Appl. No. 09/955,565
Amdt. Dated August 20, 2003
Reply to Office action of May 21, 2003

Appl. No.: 09/955,565
Amdt. Dated: August 20, 2003
Reply to Office Action of May 21, 2003
Atty Docket: IMEC222.001AUS
Annotated Sheet Showing Changes

Figure 1: prior art

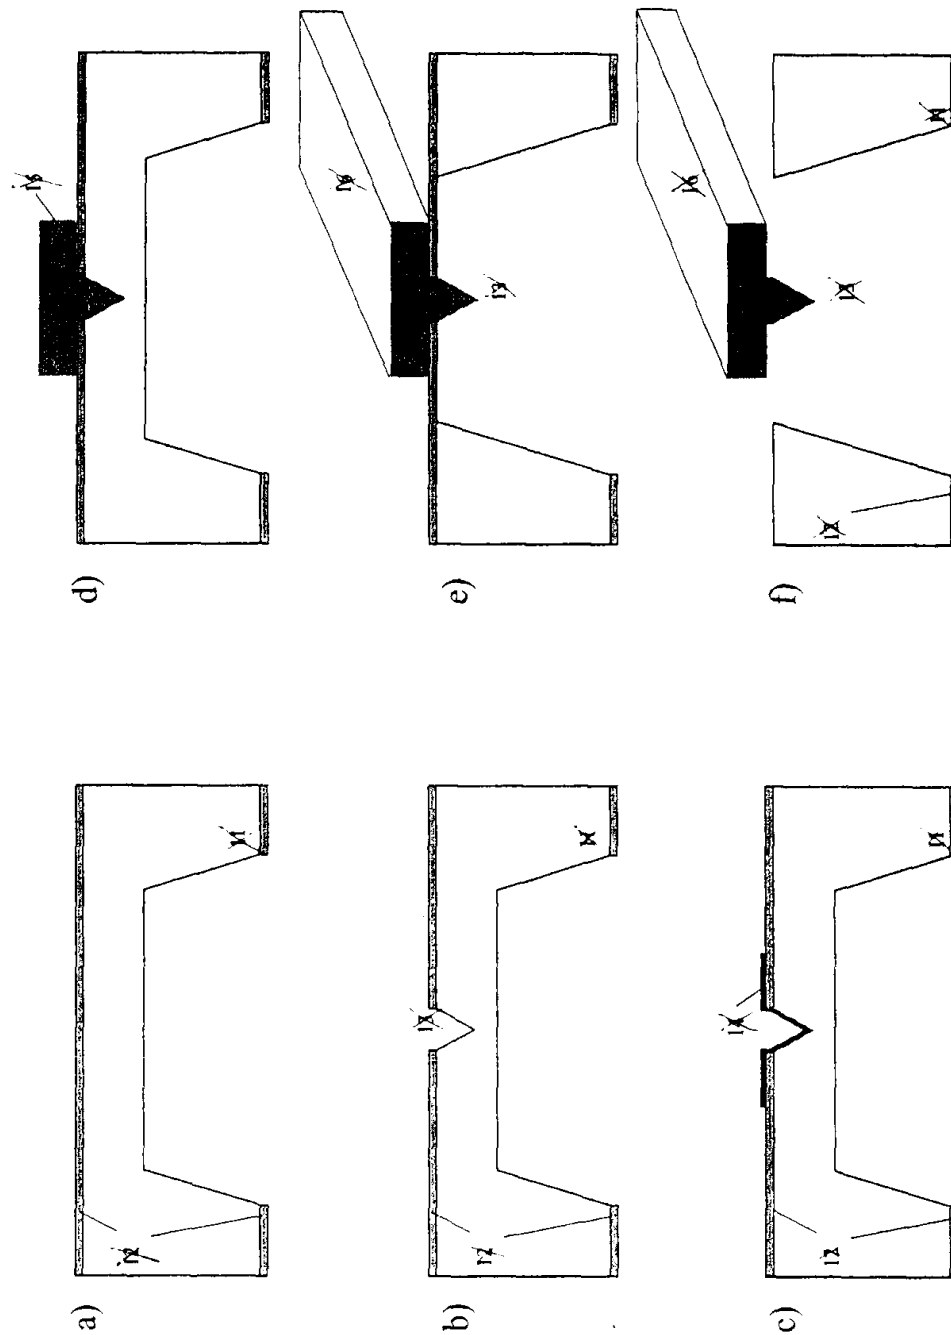
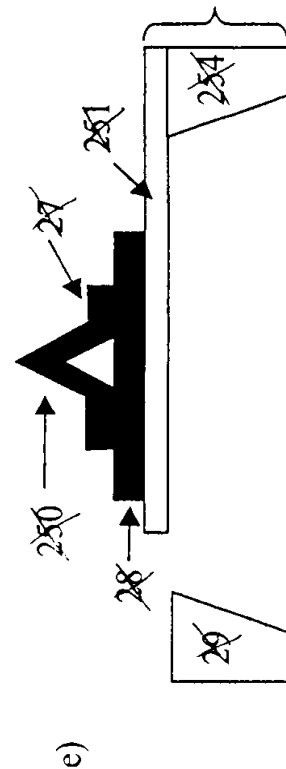
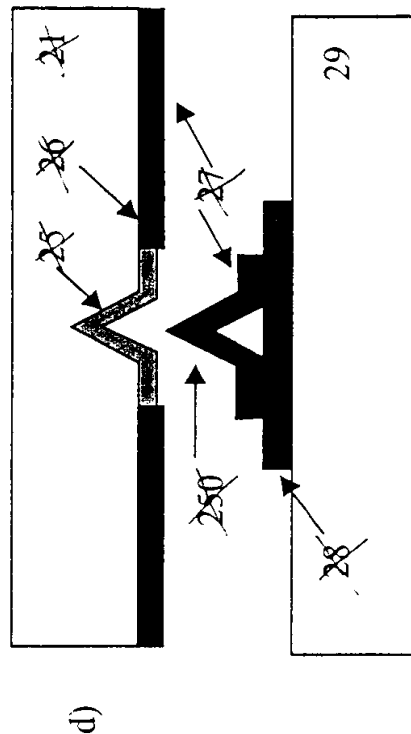
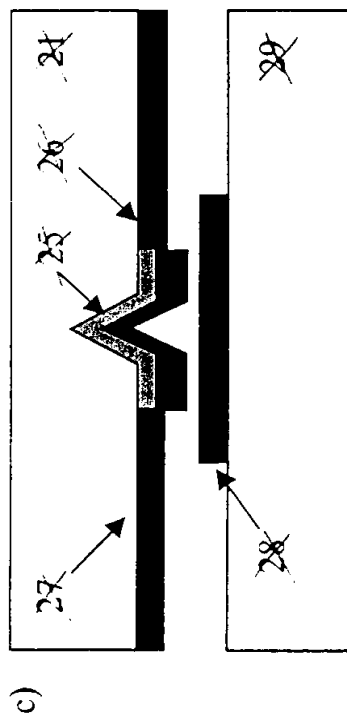
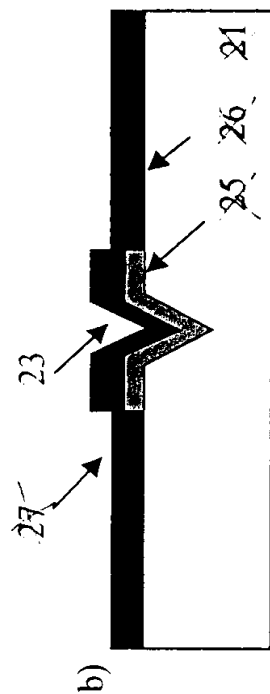
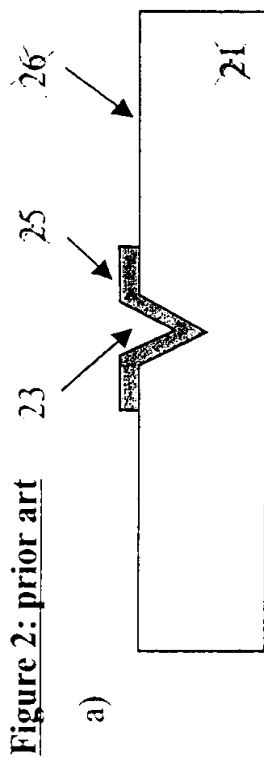
In paragraph 1 of the Office action, the Examiner objected to drawings because elements 11-16 of Figures 1a-f; elements 21, 23, 25-90, 250, 251, 254 of Figures 2a-e are not mentioned in the written description in violation of 37 C.F.R. § 1.84(p)(5). As indicated above, the Applicant has amended Figures 1a-f and 2a-e to remove reference signs that are not mentioned in the specification. In paragraph 2 of the Office action, the Examiner objected to the drawings because they do not include reference sign 37 (contact area), which is mentioned in the specification. The Applicant has corrected Figures 3c and 8b to clearly show the contact area 37. Finally, the Examiner objected to the drawings, because the drawings do not allegedly show certain features recited in Claims 19 and 20. Since the Applicant has cancelled Claims 19 and 20, the Applicant submits that the objection to the drawings is now moot.
